Product Change Notification / ASER-05IJPW824

CCB 4556 Final Notice: Qualification of SIGN as a new assembly site for selected SST39V320xx and SST38VF640xx device families available in 48L TSOP (12x20mm) package.

CCB 4556
Pre and Post Change Summary
PCN#: ASER-05IJPW824

PCN # ASER-05IJPW824

LPI

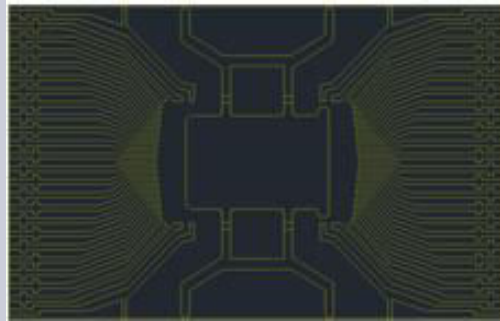
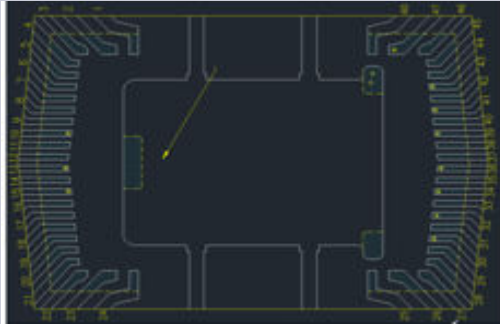
Lead Frame Paddle size	207 x 142 mils
------------------------	----------------

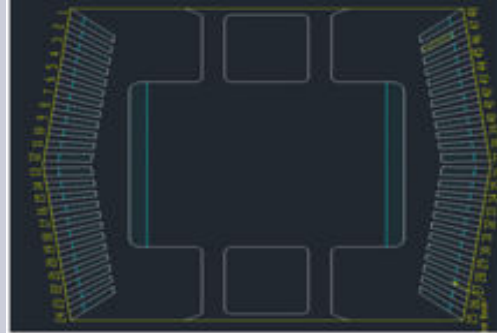
Lead Frame Paddle size	183 x 161 mils
------------------------	----------------

SIGN

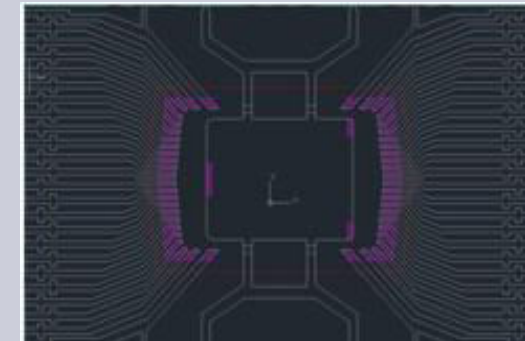
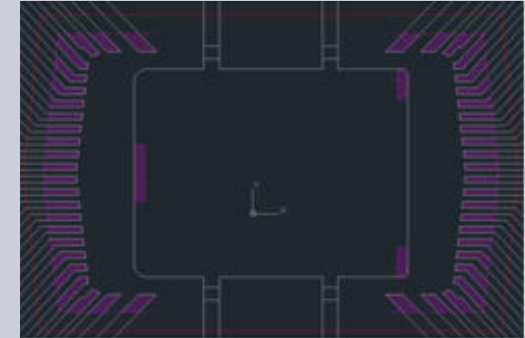
Lead Frame Paddle size	209 x 165 mils
------------------------	----------------
